FINAL REPORT WASTEWATER TREATMENT MASTER PLAN PHASE I

MARINE CORPS BASE CAMP LEJEUNE, NORTH CAROLINA

CONTRACT NO. N62470-90-D-6706

Subj: WASTEWATER MASTER PLAN

WASTEWATER TREATMENT MASTER PLAN PHASE I	
MARINE CORPS BASE	CAMP LEJEUNE, N.C.
EXISTING TREATMENT PLANT SITES	
SCALE: N.T.S.	FIGURE 1.0

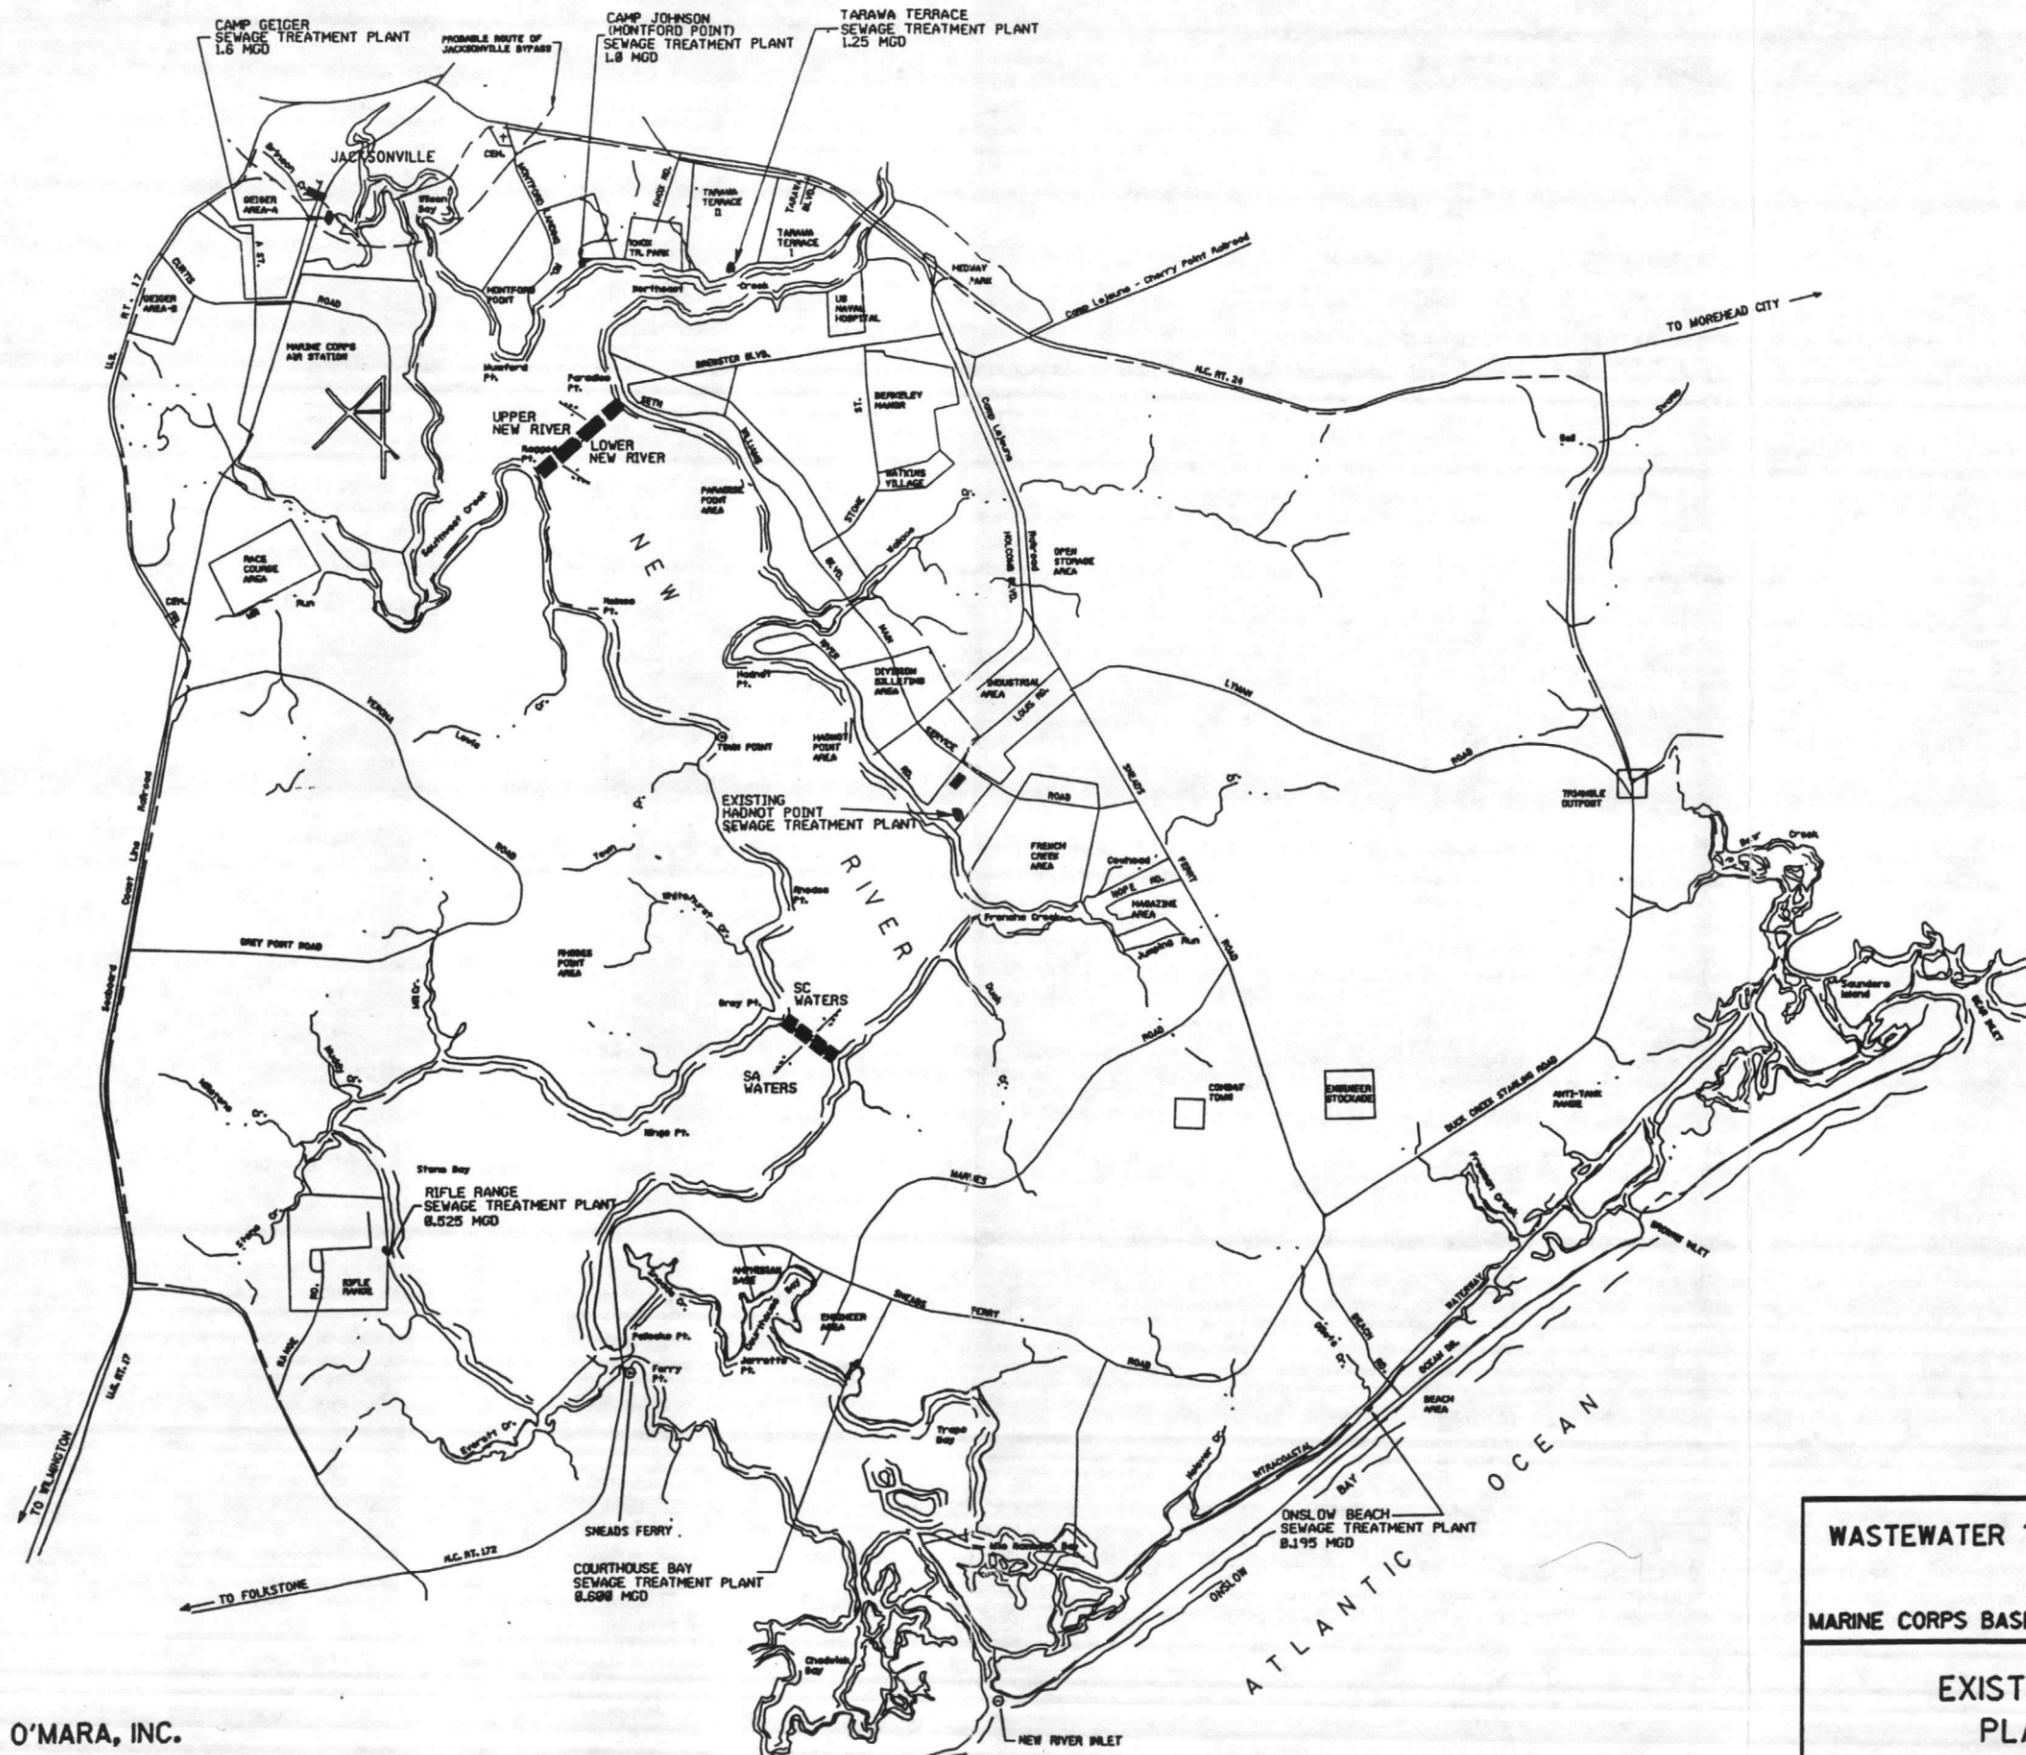
Gonzales Blvd
& Main Service
Rd. Has
this changed

SCALE: N.T.S. FIGURE 3.3

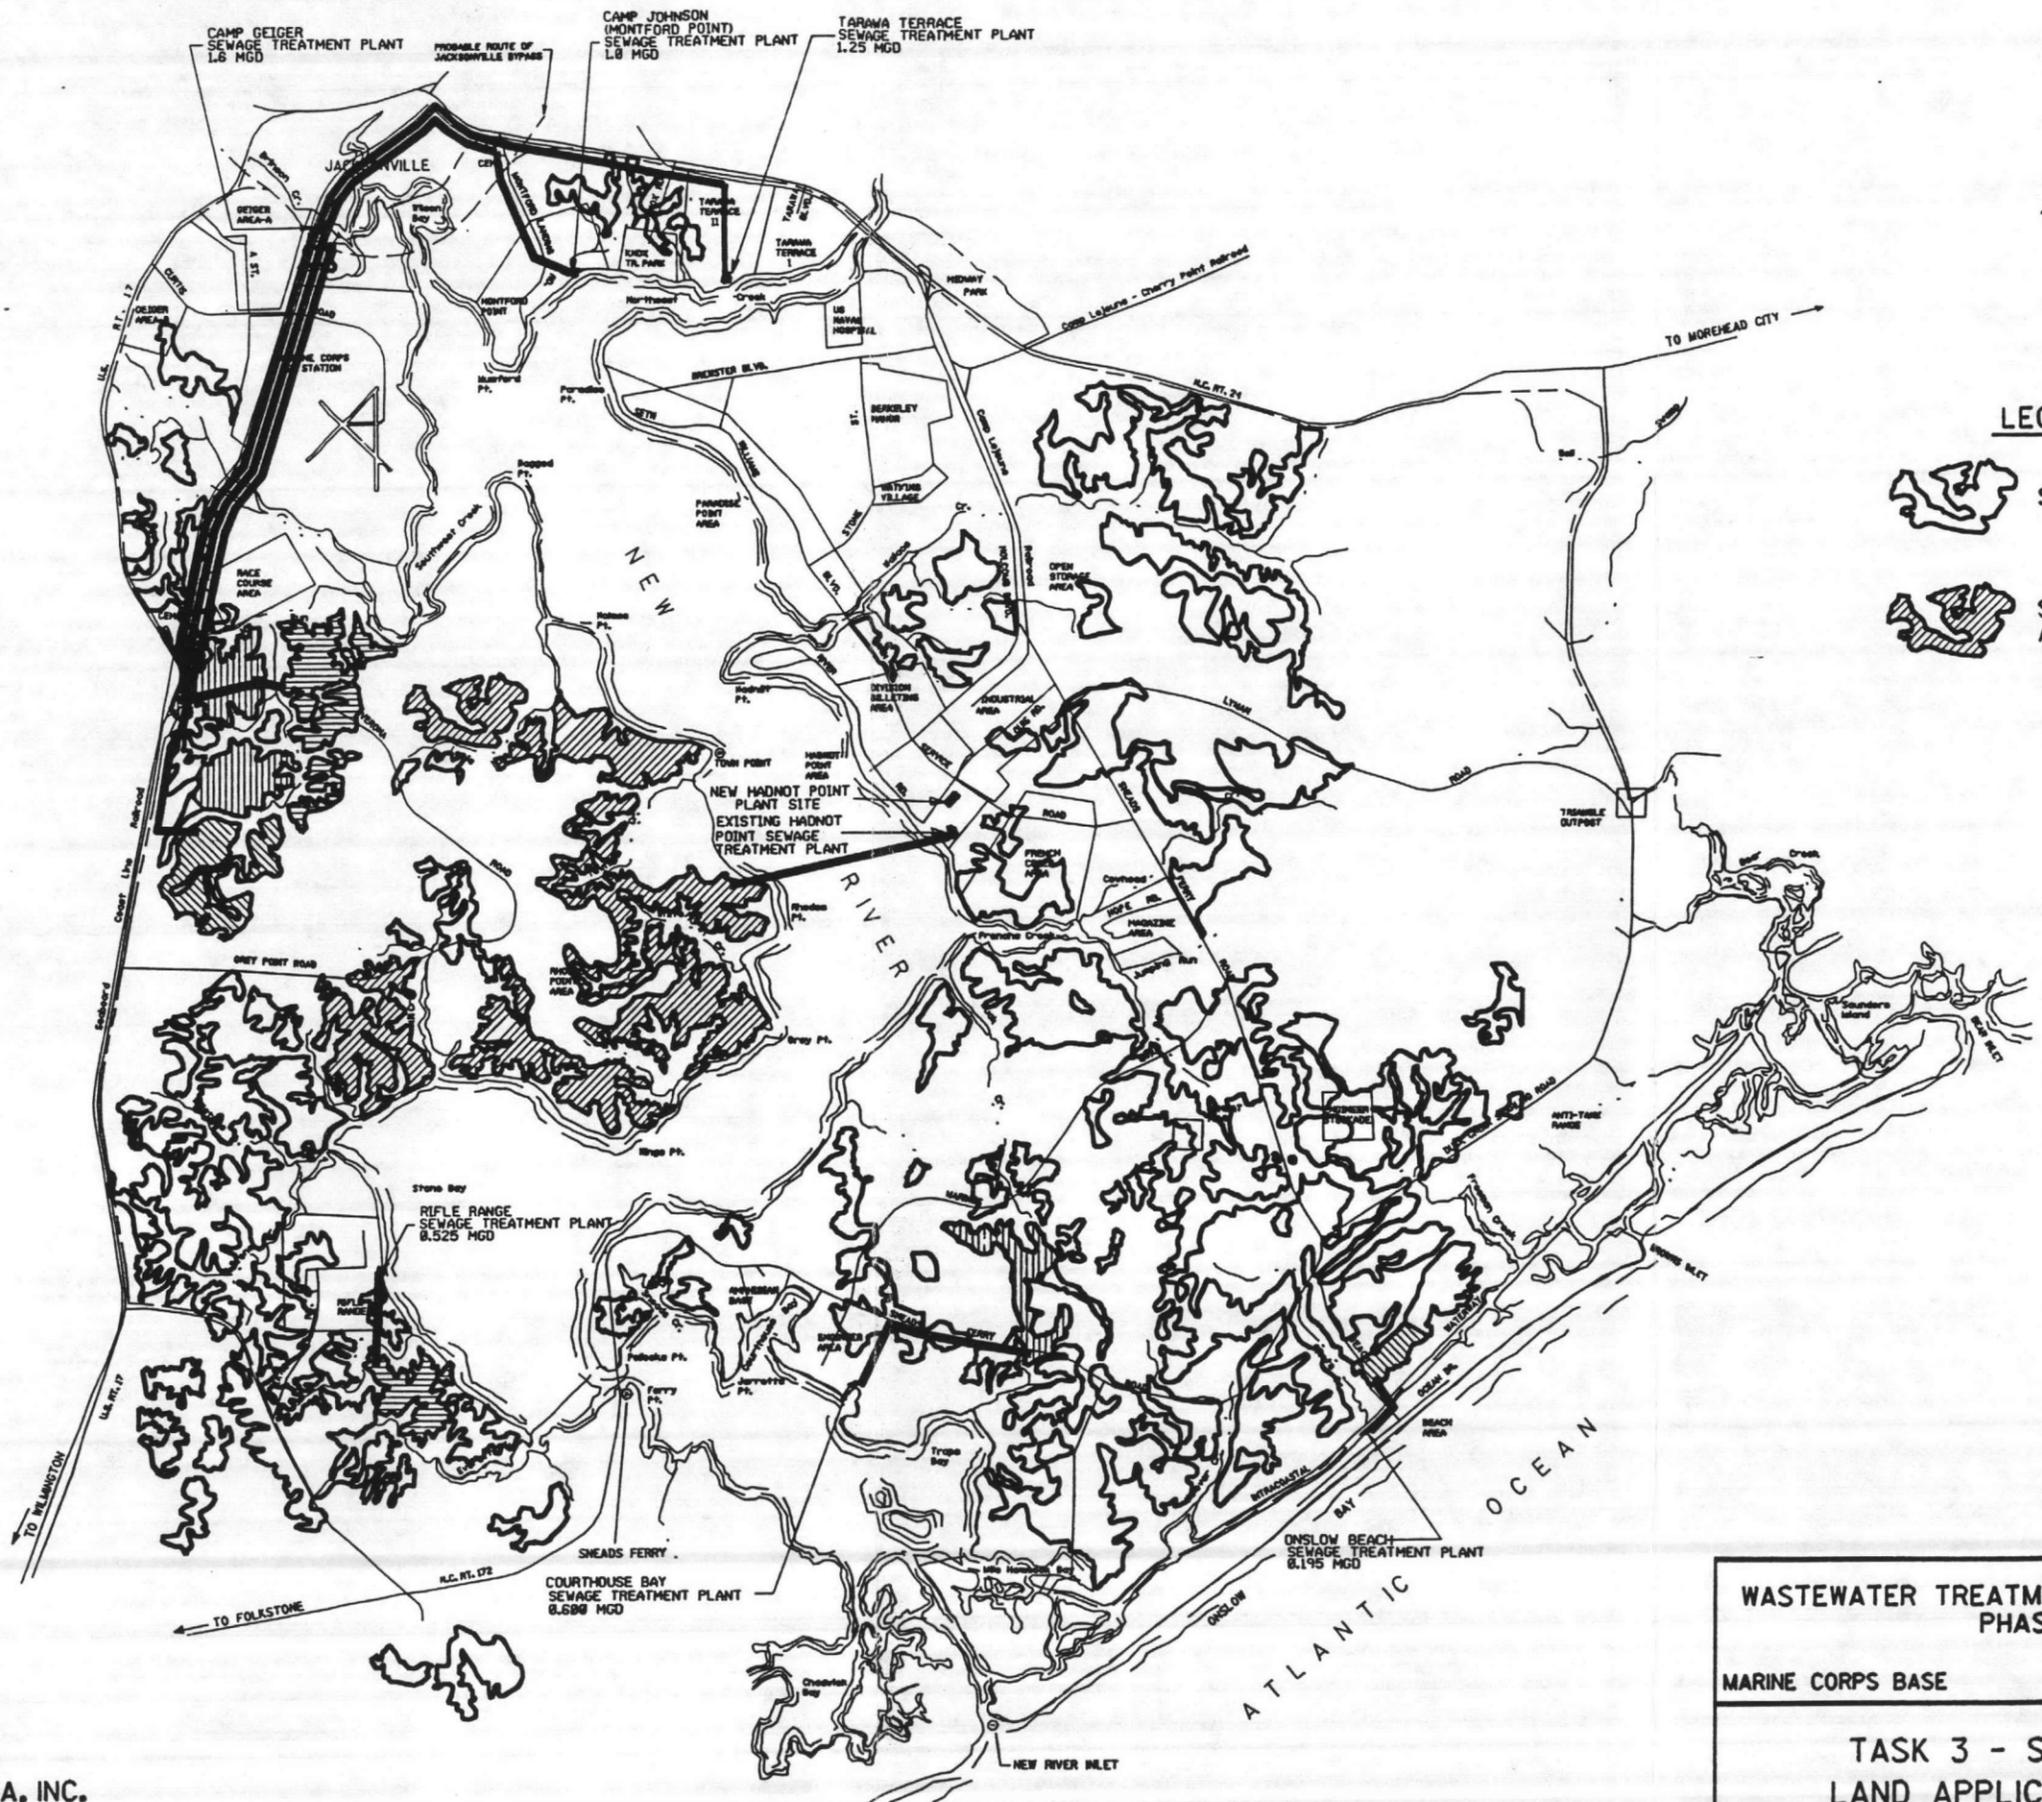
This may be a spurious assumption and
may have slanted the analysis of this
alternative
